CITY PLANNING COMMISSION

- APPLICATION:
1. Environmental Determination
 2. Rezone 16± vacant acres from Agricultural (A) and Highway Commercial (HC) to the Townhouse (R-1A) zone
 3. Tentative Map (Subdivision Ordinance)
 4. Special Permit to develop 56 zero lot line and 60 halfplexes (Sec. 7-C, Zoning Ordinance)
 5. Subdivision Modification to create reverse frontage lots (Sec. 40.326, Subdivision Ordinance)

LOCATION: Southwest corner of Bell Avenue and Taylor Avenue

APPLC. NO. PR4-019

CONCEPTUAL SITE PLAN

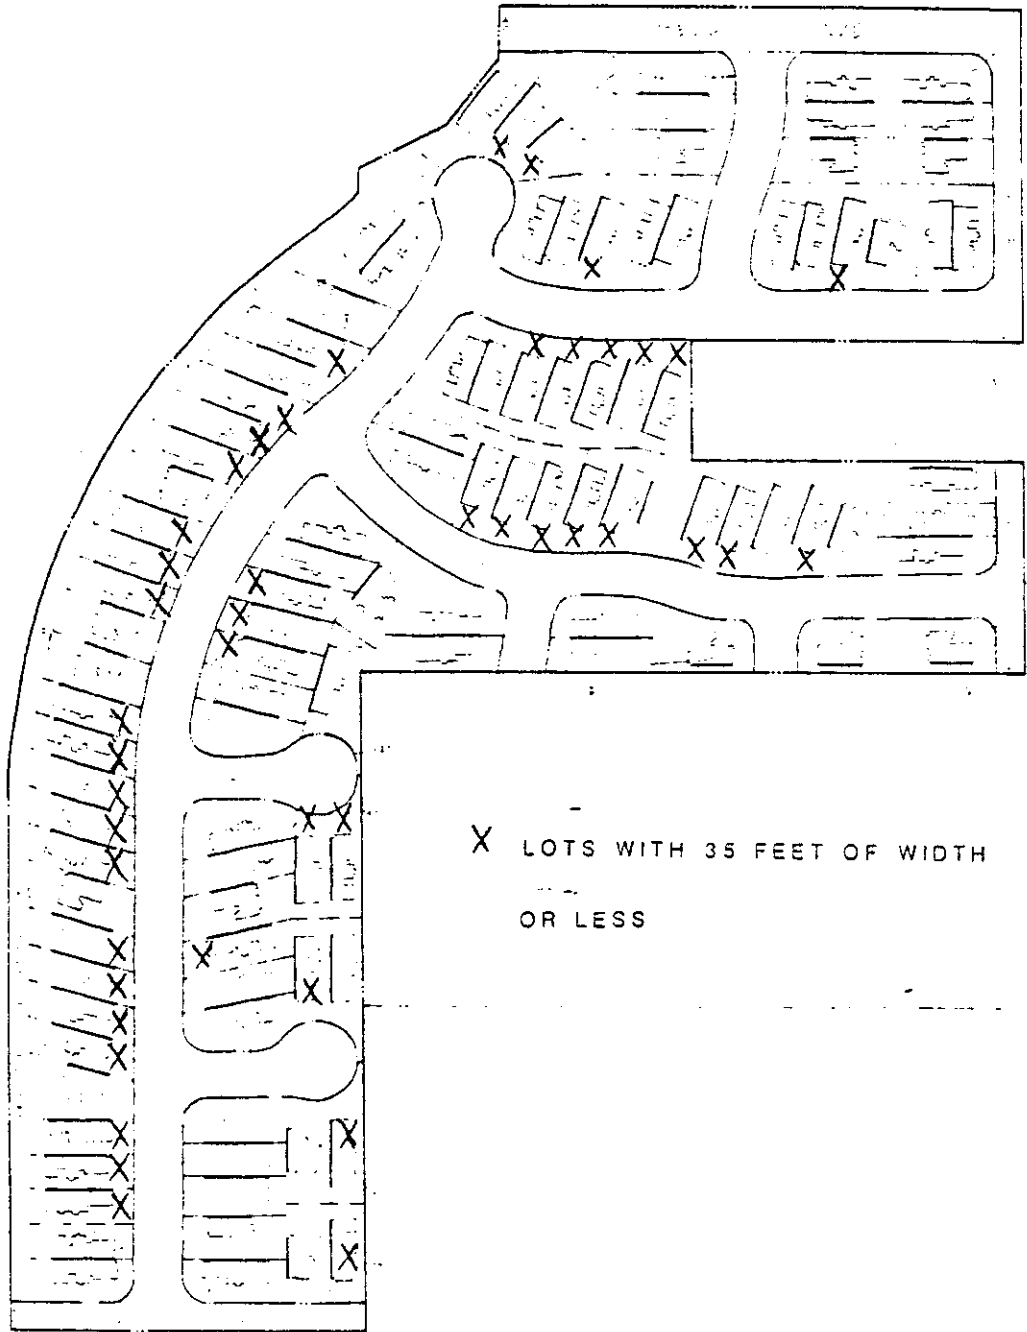
4. Although staff has no objections to the concept of developing the site with zero lot line and halfplex units, staff does have concerns over the design of this project. Forty-one of the proposed zero lot line lots in this development are 35 feet wide, four lots are 30 feet wide or less and because of the narrow lotting pattern the structure design is limited. As proposed, 83% of the units are only 25 feet wide which limits the possibility of solar access for a majority of the north/south oriented lots. The narrow lots have also created a situation where the minimum setback between zero lot line units is less than 10 feet, which has been the standard minimum setback approved for this type of development. This proposal indicates that the maximum setback achievable between some of the units is only 7-1/2 feet. A condition has been placed on the map to require a minimum of 10 foot setback between units, which may further reduce the width of some units.

6. As proposed, the applicant's plans indicate dual street frontage for two of the lots along Bell Avenue. The applicant proposes to develop these two sites with back-on lots which is contrary to the proposed residential design criteria for development adjacent to major streets. Staff has recommended these lots be redesigned using the proposed design criteria for subdivisions located on major streets. The applicant has, however, indicated that modification is not possible for these lots due to grading variation of the drainage ditch along Bell Avenue. The City Engineer indicated that front-on lots with access on Bell Avenue would not be possible due to the grading variation and close proximity to the bridge.

7. The applicant needs to propose major changes in an effort to gain staff support for the halfplex and zero lot line development. Staff recommends expansion of the lots to a minimum width of 45 feet. The roof lines should be changed to provide more variety on front elevations. In addition, the units should be widened to accommodate more exposure of the living area to the street.

REVISED
ELEVATIONS
1 MAR 84

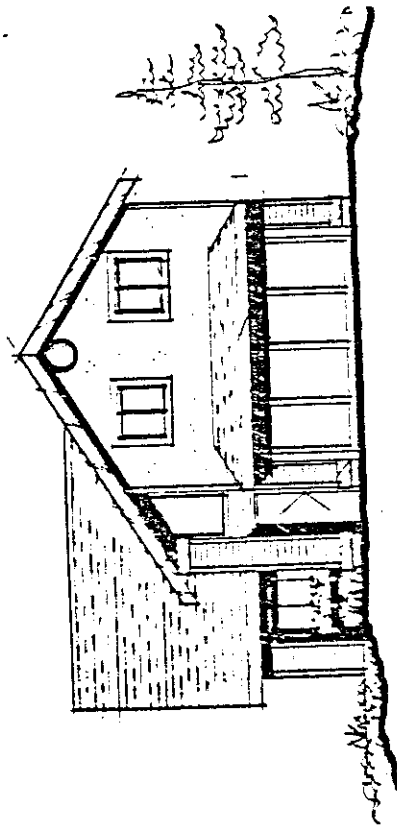
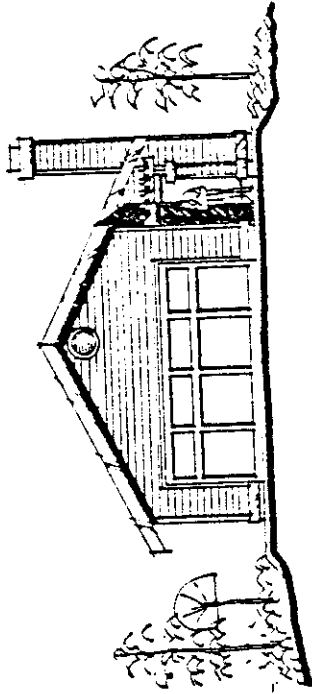
5. Staff also has concern over the design of the structures. As proposed, the 25 foot wide units will be developed with little or no unit orientation on the street other than the garage. The predominance of garage frontages will create a monotonous streetscape and adversely affect the design of the neighborhood. In addition, the lack of street oriented units may create future security problems in that the living area of the structure will be isolated from the street and prevent the resident from monitoring neighborhood and street activity. In an effort to address staff's concerns over the structure design, the applicant submitted revised plans. In reviewing the applicant's revisions, staff finds no discernable difference between these plans and those originally submitted. The floor plans are substantially the same and the predominant feature on the front elevations are the garages.
